**STATE OF NEW MEXICO
BEFORE THE WATER QUALITY CONTROL COMMISSION**

OPPOSED MOTION FOR REMAND

**RE: DISAPPROVAL
DRAFT AQUEOUS FILM-FORMING FOAM RELEASE AREAS PHASE I REMEDIAL
INVESTIGATION WORK PLAN
CANNON AIR FORCE BASE, NEW MEXICO
EPA ID #NM7572124454
HWB-CAFB-21-002**

Figure 4-3

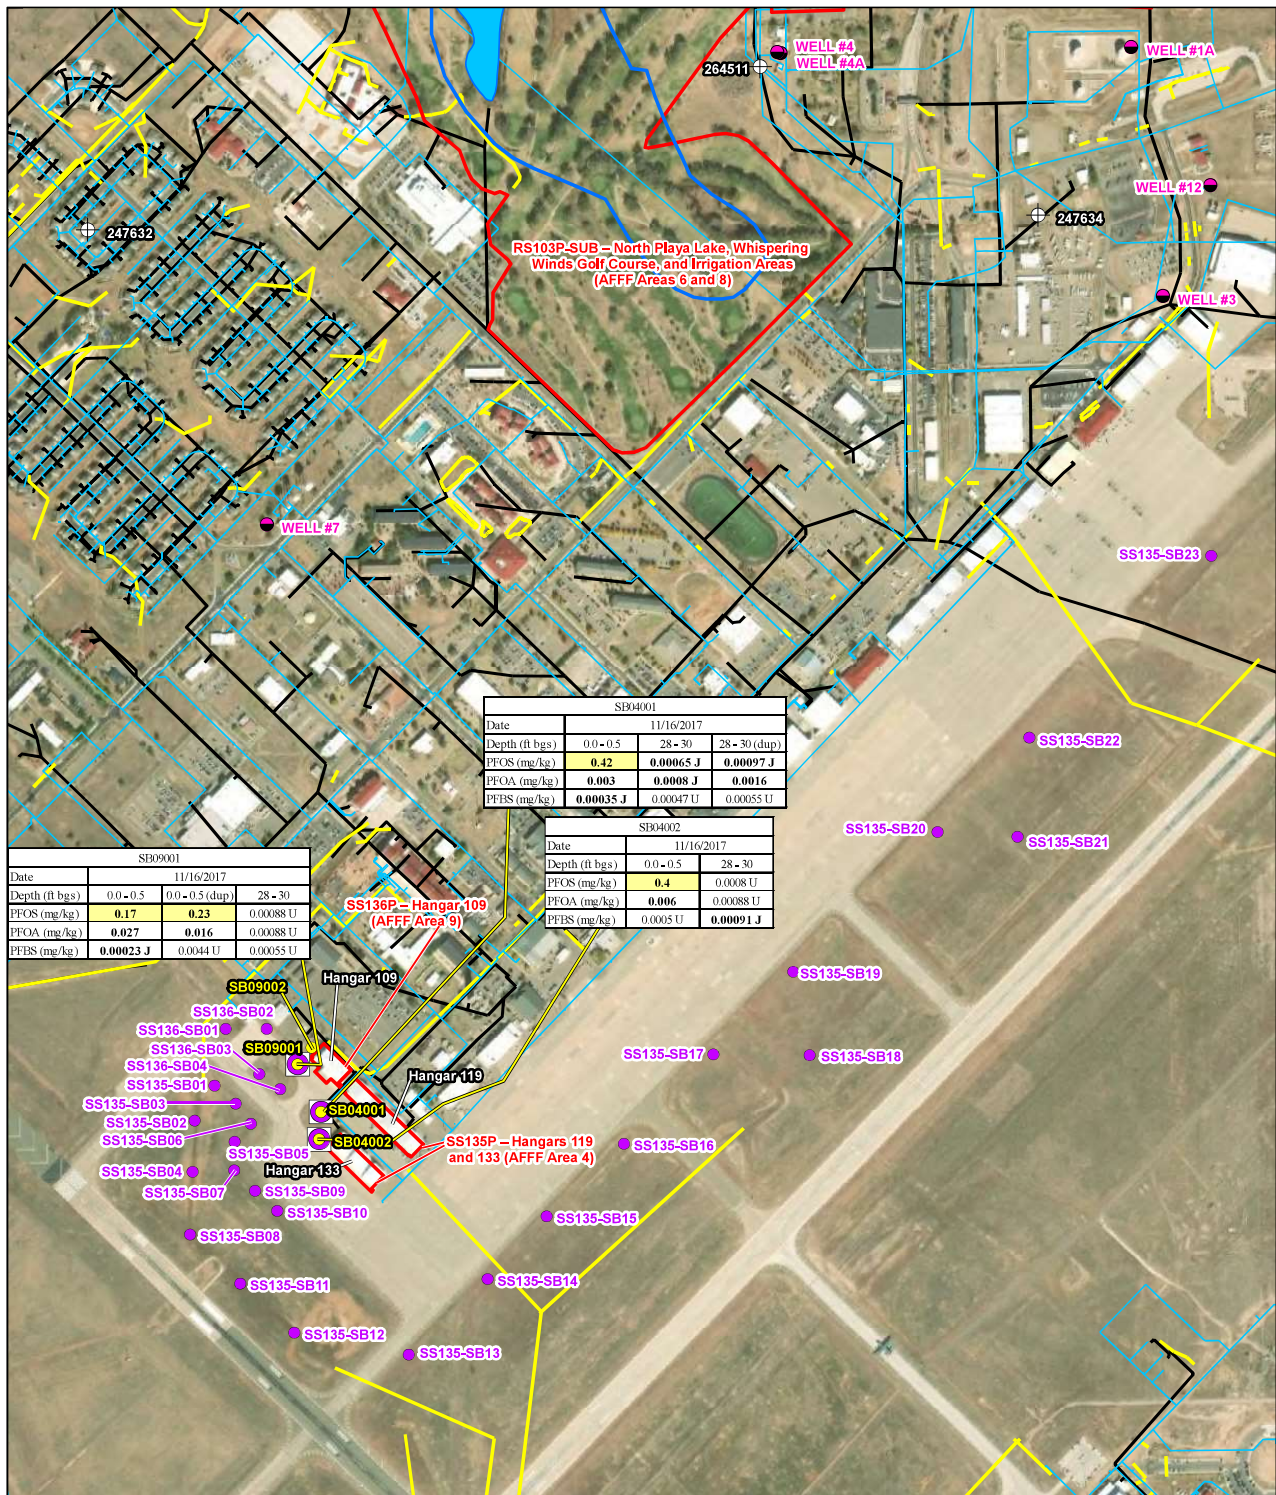
NMED Comment: Based on NMED’s review of Section 4.11, referenced Table 4-4, and Figures 4-1 through 4-8, the Permittee must address the following comments:
